PROPOSED IMPROVEMENT  
 TOWN OF WEATHERSFIELD  
 COUNTY OF WINDSOR  
 VT ROUTE 131 (RURAL MAJOR COLLECTOR)  
 BRIDGE NO: 11B

RECORD PLANS

PROJECT DESCRIPTION: THE PROJECT SHALL CONSIST OF LINING THE EXISTING CULVERT WITH A CURED-IN-PLACE PIPE (CIPP) LINER AND MINOR HEADWALL REPAIRS.

PROJECT NAME: WEATHERSFIELD  
 PROJECT NUMBER: STP 0146 (111)

FILE NAME: z00d268-notes.dgn  
PROJECT LEADER: J. FITCH  
DESIGNED BY: K. RUTTER  
PROJECT NOTES

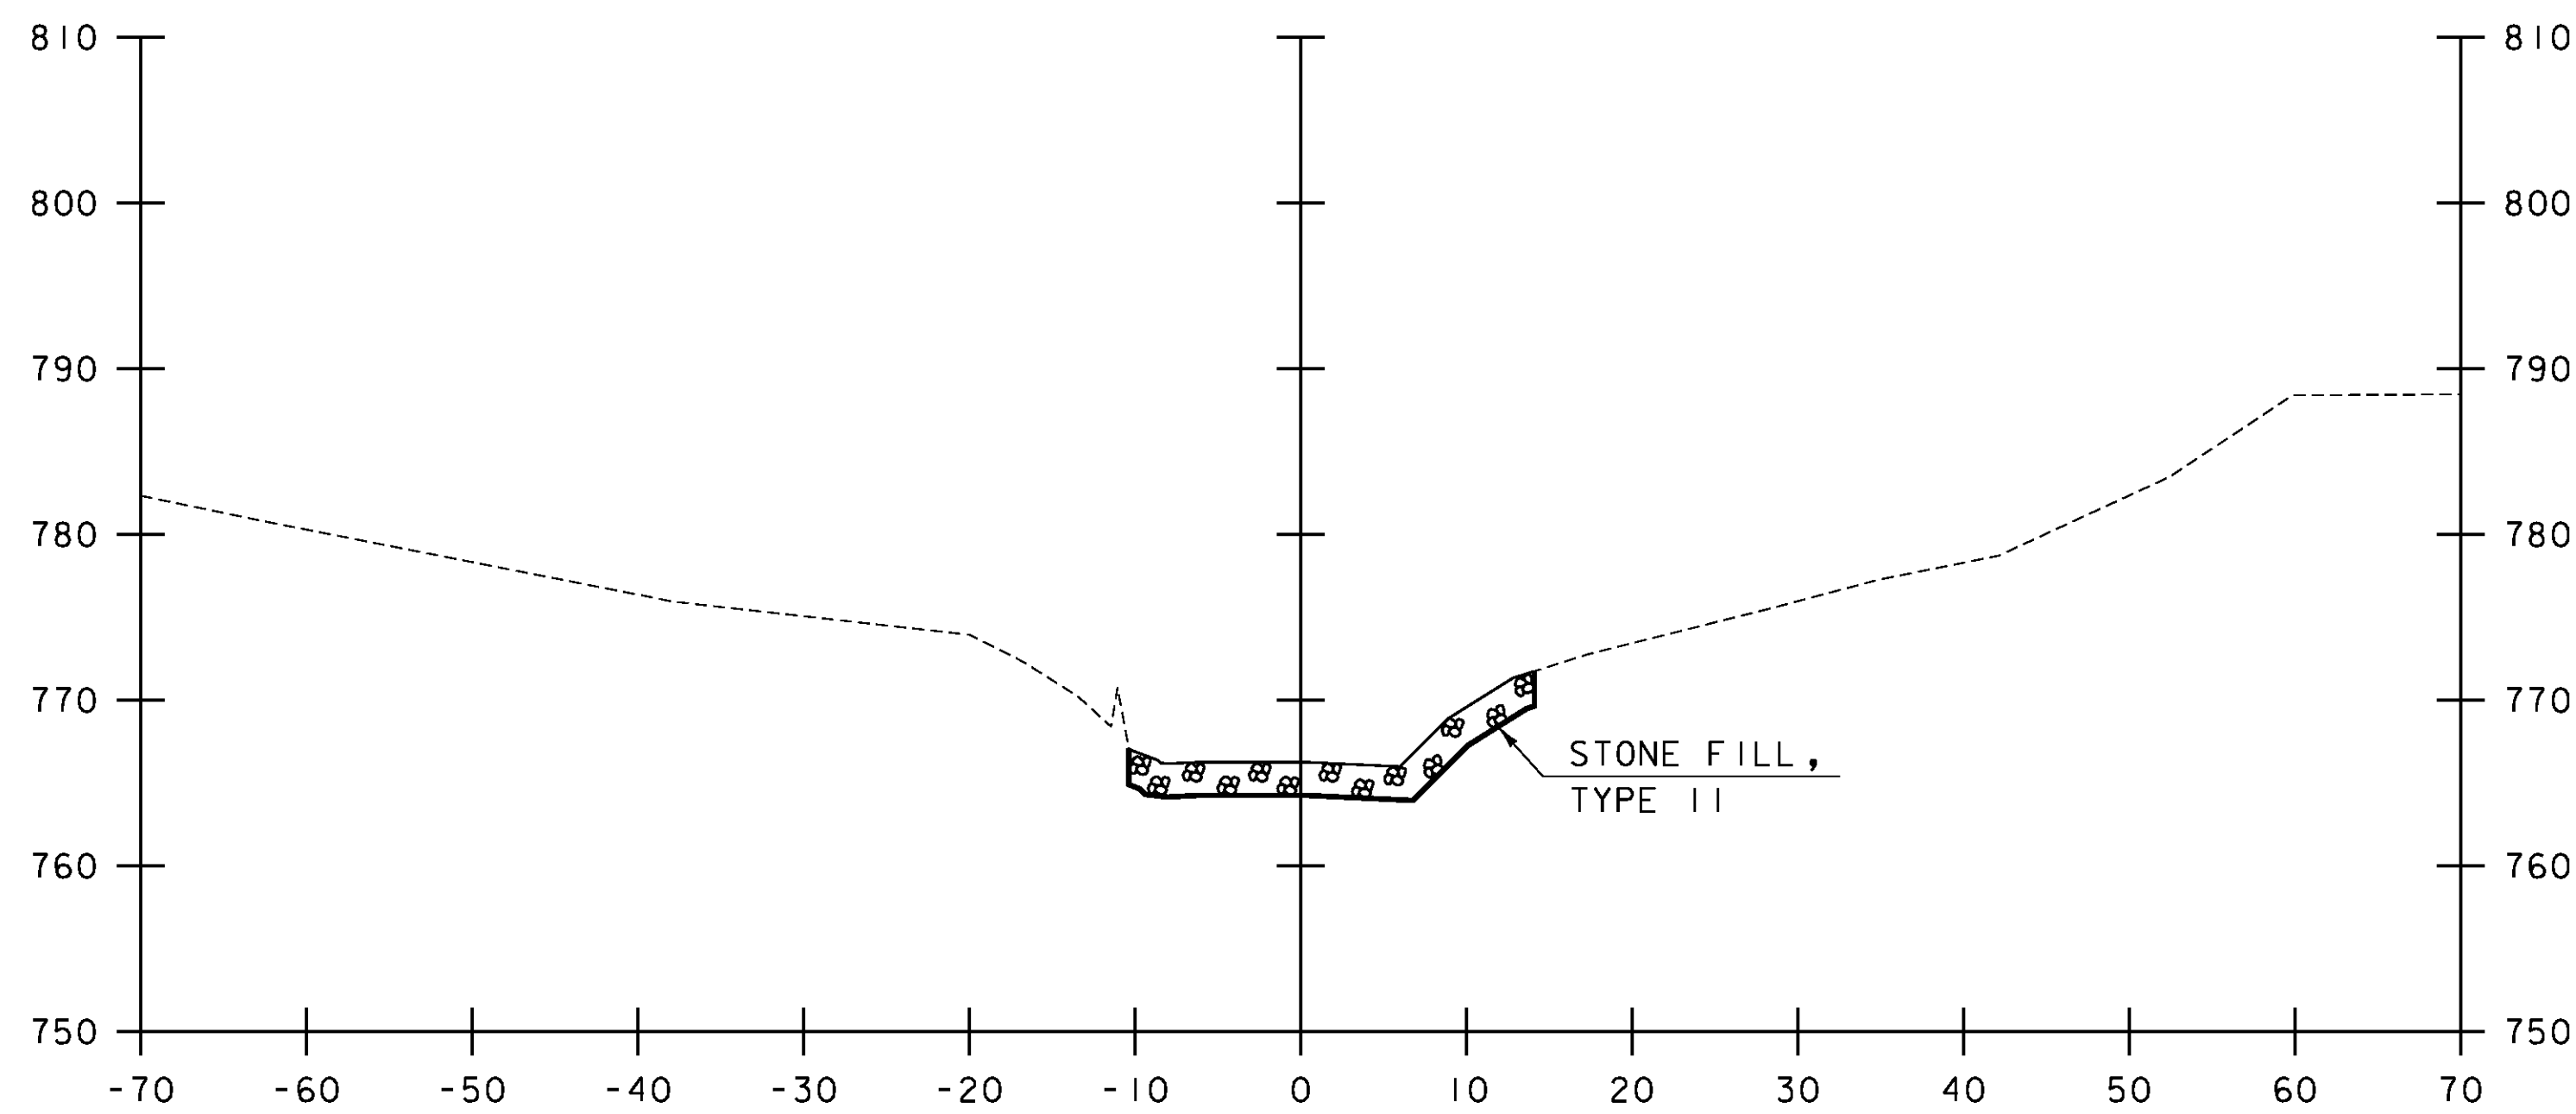
1. CONCRETE PAYMENT AND CLASSIFICATION WILL BE AS FOLLOWS:
  - A. FILLING VOIDS BELOW PIPE OHW FLOW LINE: ITEM 541.31, CONCRETE CLASS D
  - B. FILLING VOIDS ABOVE PIPE OHW FLOW LINE: ITEM 541.45, CONTROLLED DENSITY (FLOWABLE) FILL
2. ALL EXPOSED EDGES OF CONCRETE SHALL BE CHAMFERED 1 INCH BY 1 INCH, UNLESS OTHERWISE NOTED.
3. JOINTS AND SCORE MARKS IN CONCRETE SHALL BE CONSTRUCTED AS INDICATED IN THE PLANS OR AS DIRECTED BY THE ENGINEER.
4. WATER REPELLENT, SILANE SHALL BE APPLIED TO ALL EXPOSED CONCRETE SURFACES. PAYMENT WILL BE MADE UNDER ITEM 541.0, "WATER REPELLENT", SILANE". APPLICATION RATE OF "WATER REPELLENT", SILANE" SHALL BE IN ACCORDANCE WITH THE MANUFACTURER'S RECOMMENDATIONS UNLESS OTHERWISE DIRECTED BY THE ENGINEER.  
**REPLACED CONCRETE, CLASS D AND CONTROLLED DENSITY (FLOWABLE FILL) WAS REPLACED WITH OVERHEAD/VERTICAL REPAIR MATERIAL.**

5. **USED OVERHEAD/VERTICAL REPAIR MATERIAL.**  
THE CONTRACTOR SHALL FILL ANY VOIDS ABOVE THE ORDINARY HIGH WATER MARK IN THE CULVERT FROM WITHIN THE CULVERT BEFORE INSTALLING THE LINER. PAYMENT FOR THIS WORK SHALL BE MADE UNDER ITEM 541.45, "CONTROLLED DENSITY (FLOWABLE) FILL".

6. **USED OVERHEAD/VERTICAL REPAIR MATERIAL.**  
THE EXISTING MARBLE HEADWALLS SHALL BE RETAINED AT EACH END OF THE CULVERT. REPAIRS TO THE EXISTING HEADWALLS SHALL BE COMPLETED AS SHOWN IN THE PLANS. DURING THE COURSE OF CONSTRUCTION IF THE CONTRACTOR SEES ADDITIONAL REPAIRS THAT SHOULD BE MADE TO THE EXISTING HEADWALLS, IT SHALL BE BROUGHT TO THE ATTENTION OF THE ENGINEER. THE ENGINEER WILL MAKE A DETERMINATION IF THE ADDITIONAL REPAIRS SHALL BE MADE. THIS WORK SHALL BE PAID UNDER ITEM 602.40, "REPAIRING STONE MASONRY". ITEM 602.35, "REBUILT STONE MASONRY" OR ITEM 602.30, "POINTING MASONRY".
